SB-GA8-2012-67

Service Bulletin

Flap and Aileron Hinge Wear Repair

Figure 1 - Lubricating hole

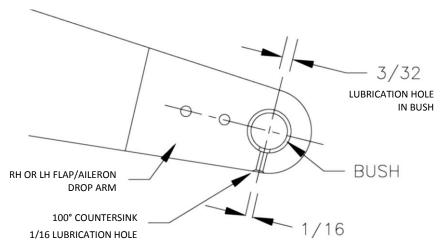
- 1. Carry out a general inspection of the aileron and flap drop arms.
- 2. If the hinge bolt hole in the aileron and/or flap drop arm is worn or damaged follow the procedure below, otherwise skip to Step 3:
 - a. Remove the affected aileron or flap in accordance with GA8 Service Manual;
 - b. Drill a 1/16 inches lubrication hole in the aileron or flap drop arm, countersink at 100° and deburr. See Figure 1 as reference;

Figure 3 – Bush Installation detailed.

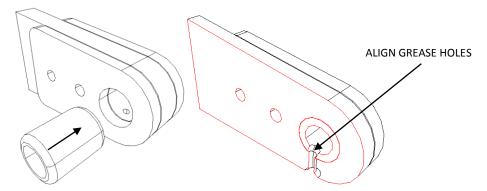
e. Apply Loctite ® 680™ (or an equivalent high strength bonding compound designed for bonding of cylindrical parts) to the bush and carefully press it into the aileron or flap drop arm ensuring that its lubrication hole aligns with the lubrication hole in the aileron or drop arm, as shown in Figure 3.
